KINGS CROSSING

PRELIMINARY PLAN NO. 120220020

Application to create 10 lots for 10 new single-family detached dwelling units and one lot for one existing single-family detached dwelling unit.

No. 120220020 Completed: 6-23-2023 MCPB Item No. 7 July 6, 2023 Montgomery County Planning Board 2425 Reedie Drive, Floor 14 Wheaton, MD 20902

Figure 5 - Proposed 11-foot Shared Use Path

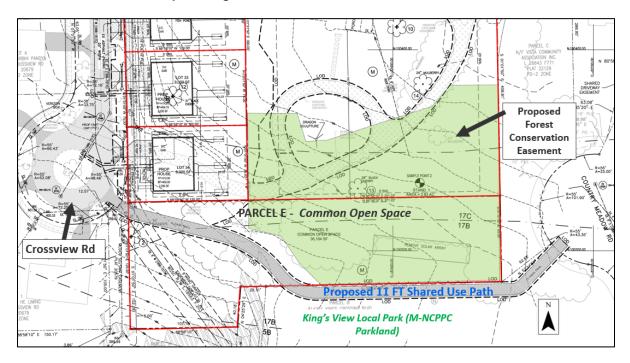
The existing sidewalk along the frontage with Autumn Gold Road will be improved to six feet (6 ft) in width to match current sidewalk standards and provide a 15-foot-wide buffer (open section with street trees and swales). Similarly, a new six-foot-wide sidewalk will be constructed along the frontage of Crossview Road. Additionally, an 11-foot-wide asphalt shared use path (see Figure 5) will be constructed to connect the Crossview Road cul-de-sac with the nearby Country Meadow Road cul-de-sac through the southernmost boundary of the Subject Property along with a small portion through King's Crossing Local Park. The shared use path will provide important bike and pedestrian connectivity to currently disconnected neighborhoods while providing additional access to the park.

Figure 6 – PFCP and Tree Variance Request Exhibit

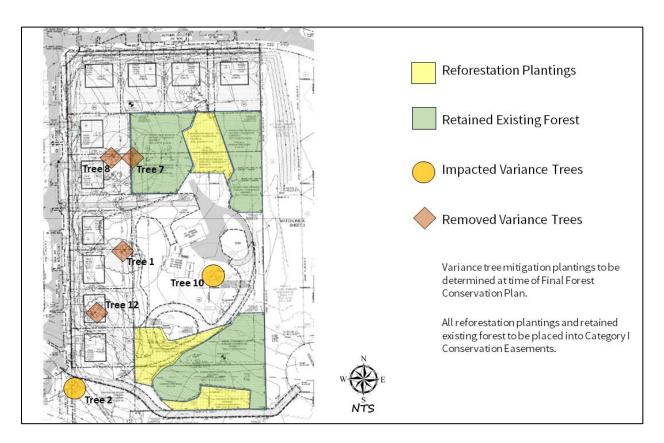
<u>Variance Request</u> - The Applicant submitted a variance request in a letter dated May 30, 2023 (Attachment G). The Applicant proposes to impact two (2) and remove four (4) trees that are 30 inches or greater DBH, that are considered high priority for retention under Section 22A-12(b)(3) of the County Forest Conservation Law (Figure 6 and Table 4).

Two Protected Trees, Tree 2 and 10, are being impacted by the limits-of-disturbance ("LOD") for the project. Tree 2 is located adjacent to a proposed shared use path between Crossview and Country Meadow Road that runs through King's Crossing Local Park. Tree 10 is being impacted by the required removal of a portion of the existing driveway on Lot 30 in order for the development to meet the 20% impervious limit set by the KI-2 area in the Germantown Master Plan.

Four Protected Trees, Trees 1, 7, 8 and 12, are proposed to be removed. Tree 12 is located within the footprint of a proposed unit; tree Trees 1 and 8, are located within the LOD and in close proximity to proposed units; and Tree 7 is located on the LOD of the development. Trees 1, 7 and 8 will have most of their CRZs removed during construction and given their current condition may become hazard trees in the future threatening the residential structures. As a result, it is recommended that these trees be removed now. The inability to impact or remove these trees would potentially render portions of the site undevelopable for this project or pose threats to the health, safety and welfare of future homeowners. Therefore, there is a sufficient unwarranted hardship to justify a variance request because the Applicant would otherwise be denied the ability to use the Property for the development of single family detached units, which is a reasonable and significant use of the Property.

by the removal of these trees. There is some disturbance within the CRZ of 2 trees, Trees 2 and 10; however, they will receive adequate tree protection measures, their roots will regenerate, and the functions they currently provide will continue. Therefore, no mitigation is recommended for trees that are impacted but retained. As conditioned, the mitigation trees will be protected as part of a 5-year maintenance and management agreement.

Fire Department Access Review

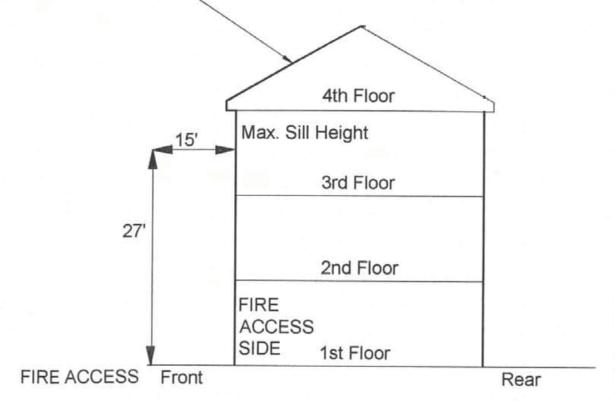
Review based only upon information contained on this plan. Does not cover unsatisfactory layout resulting from ommisions, errors or failure to clearly indicate conditions on this plan. Correction of such unsatisfactory layout to afford required access will be required if found upon inspection after installation

1. One and two-family dwellings of three (3) stories (27' to highest sill, including false dormers) or less must provide access to the occupied interior through a main, side-hinge door within 150 feet of a fire department access route. For units of three (3) stories or more, access must be within fifty (50) feet of access route.

ALL PROPOSED SINGLE FAMILY DETACHED DWELLING UNITS SHALL BE 3 STORIES OR LESS (27' TO THE HIGHTEST SILL, INCLUDING FALSE DORMERS) AND SHALL PROVIDE ACCESS TO TO THE OCCUPIED INTERIOR THROUGH A MAIN, SIDE HINGED DOOR WITHI 150 FEET OF A FIRE DEPARTMENT ACCESS ROUTE.
